Re: Harbor Grove Submittal Review Comments

We have finished reviewing the Harbor Grove submittal package per your request, following are our review comments for your information, review, and distribution to the applicant.

- Civil Plan Set for Harbor Grove, prepared by The Blueline Group, dated 8/9/22.
- Storm Drainage Report for Harbor Grove, prepared by The Blueline Group, Date: May 3rd, 2022 and Revision Date: August 9th, 2022.
- Geotechnical Engineering Study for "Daffron Property", prepared by Earth Solutions NW, LLC, dated July 30, 2021 and Updated July 28, 2022.
- Groundwater Elevation Evaluation for "Proposed Development", prepared by Cobalt Geosciences, dated March 14, 2022.
- Stormwater Pollution Prevention Plan (SWPPP) for Harbor Grove, prepared by The Blueline Group, dated 08/09/2022.
- Revised Critical Area Reconnaissance Report for Sea Pac Homes, prepared by Wetland Resources, dated December 9, 2021.

SHT **5** OF **21**

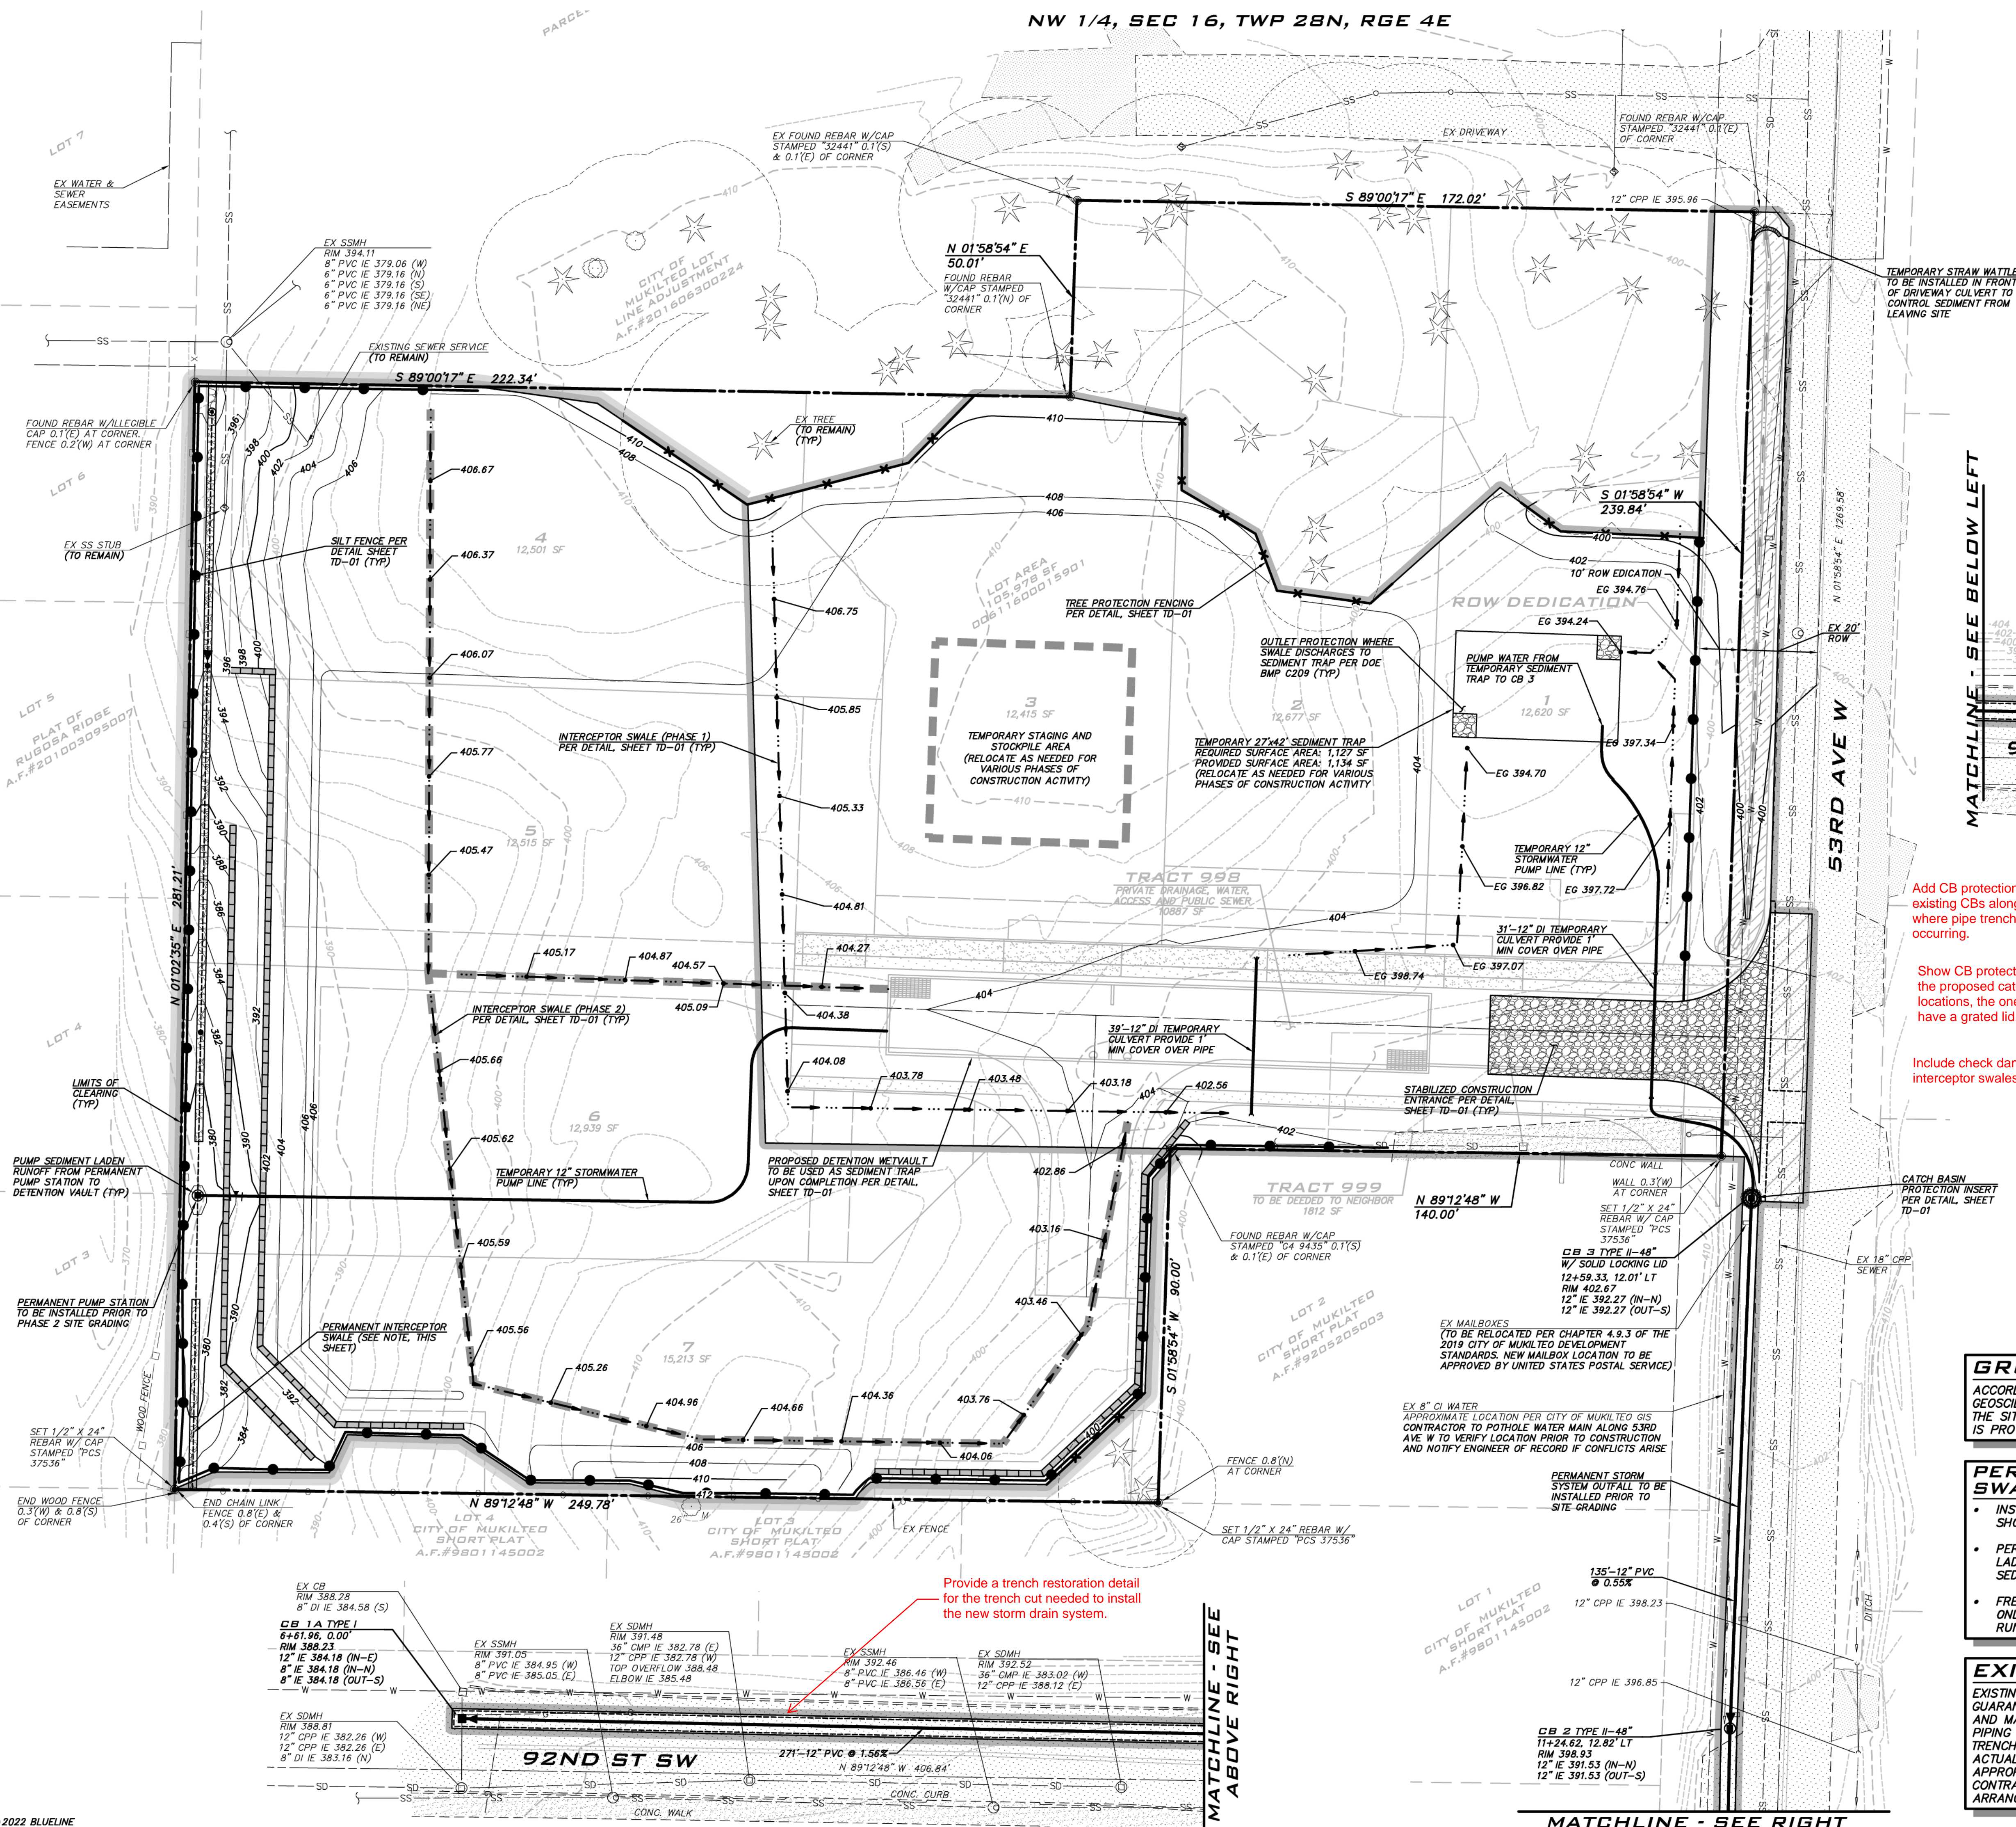
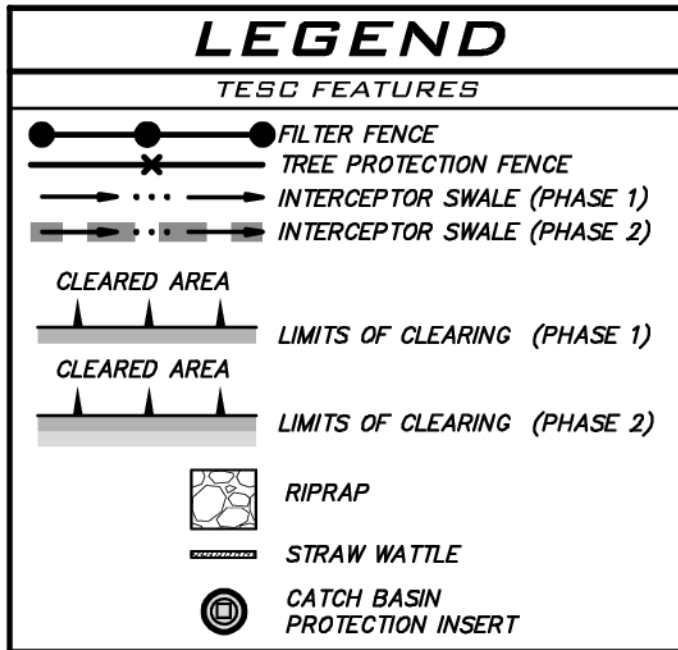
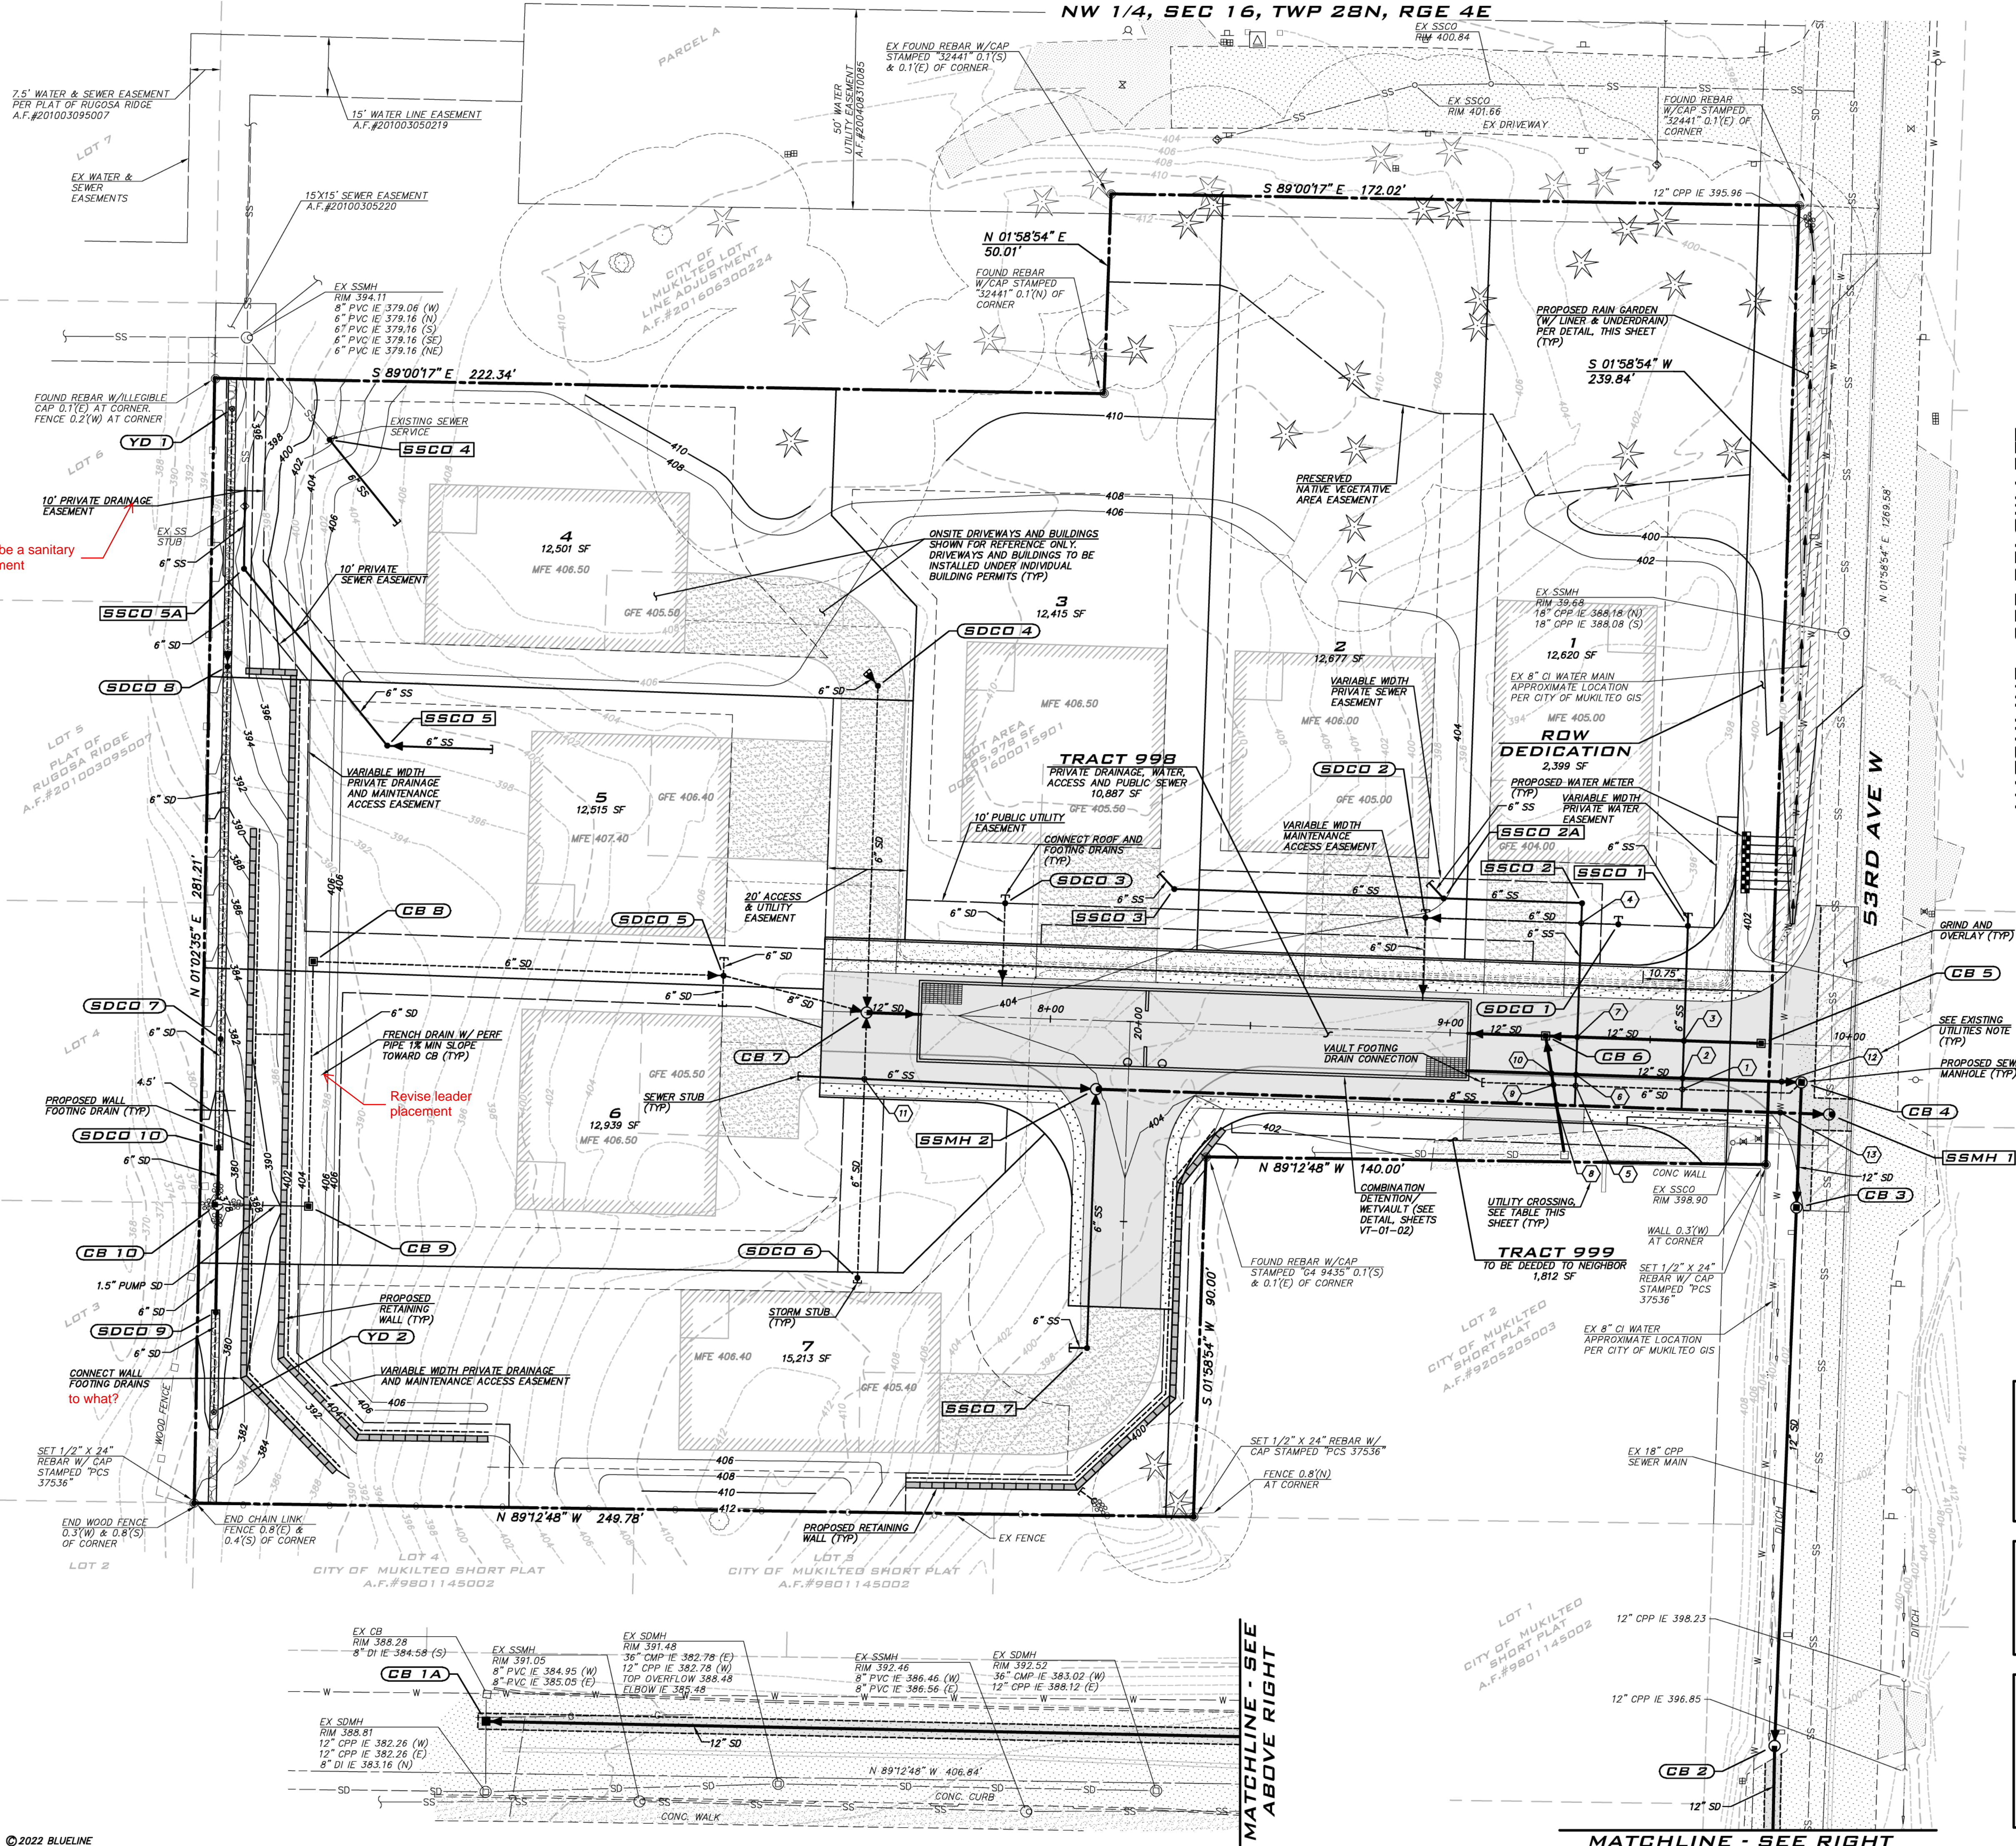
1. Provide a trench restoration detail for the trench cut needed to install the new storm drain system.
2. Add CB protection inserts to the existing CBs along 92nd St SW where pipe trench work will be occurring.
3. Show CB protection inserts for the proposed catch basin locations, the ones that will have a grated lid.
4. Include check dams along the interceptor swales.
5. EX 8" CI WATER Note: Change "CONTRACTOR TO POTHOLE" to "SHALL POTHOLE".
6. PERMANENT STORM Note: Change "TO BE" to "SHALL BE INSTALLED".

Add CB protection inserts to the existing CBs along 92nd St SW where pipe trench work will be occurring.

Show CB protection inserts for the proposed catch basin locations, the ones that will have a grated lid.

Include check dams along the interceptor swales

SHT 14 OF 21

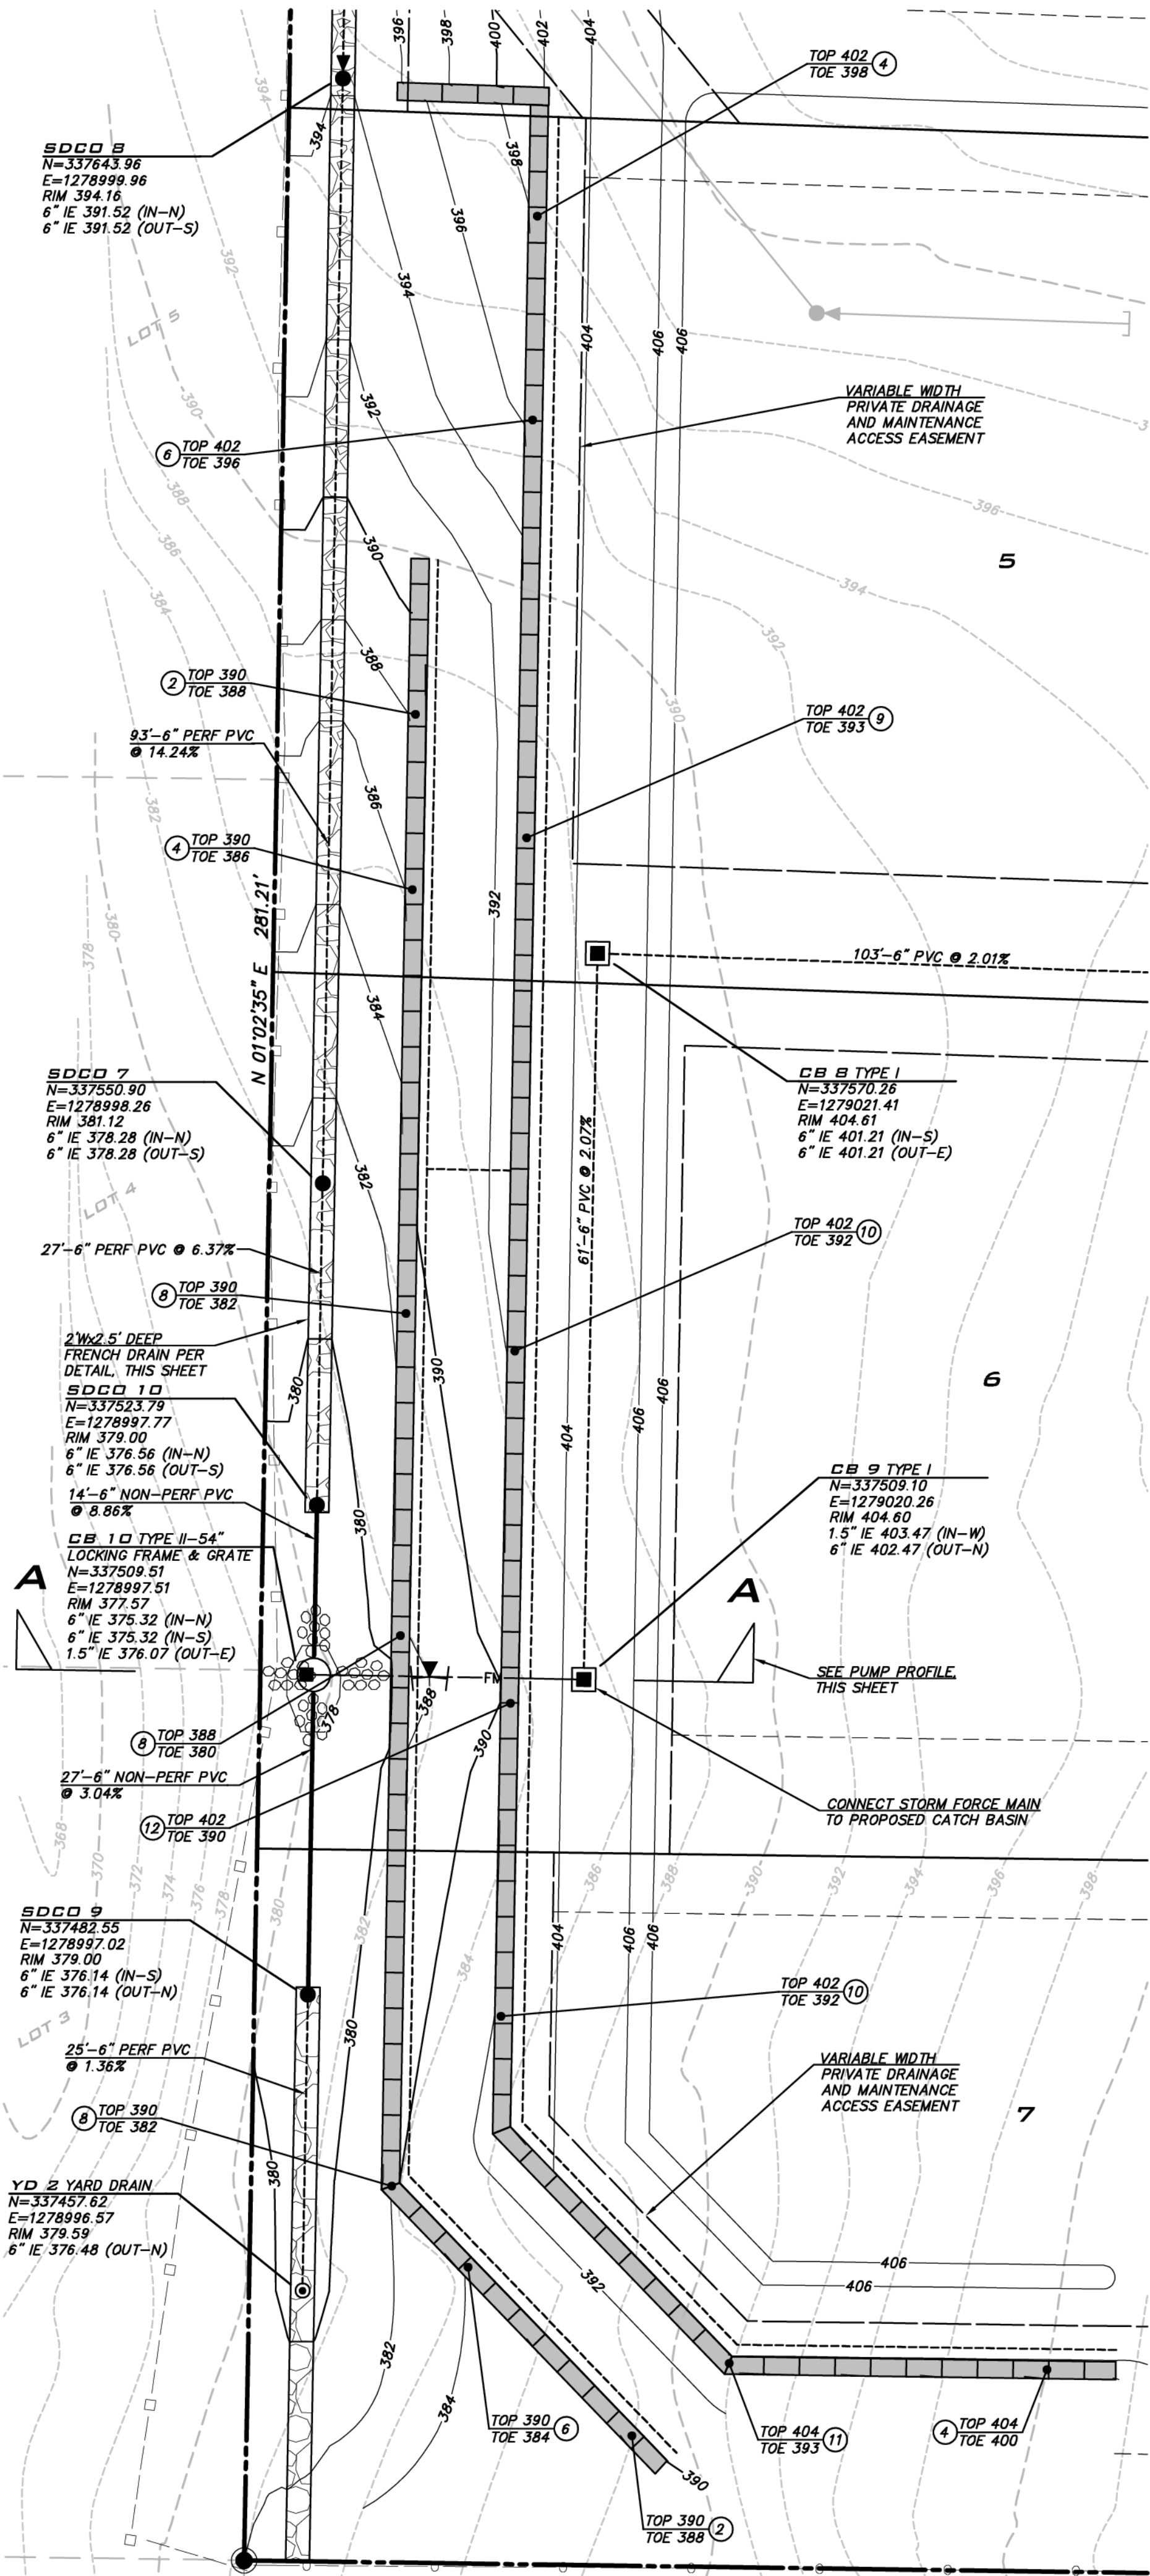
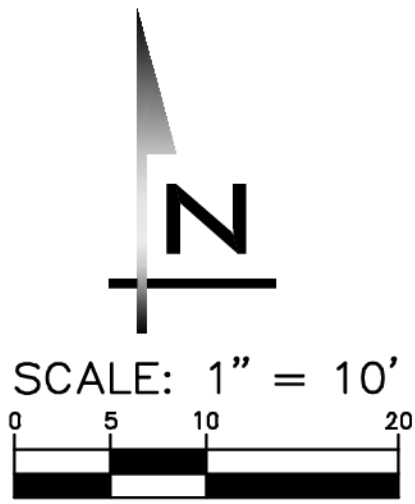
1. Drainage report states that the 2014 manual is being used for this project. Confirm which should be used by date full application is made.
2. The sump at the bottom of the vault should be a 54" sump.
3. The vault footing drain is shown in conflict with the 12" outlet pipe.
4. Per calcs the upper orifice should be 1-1/8".
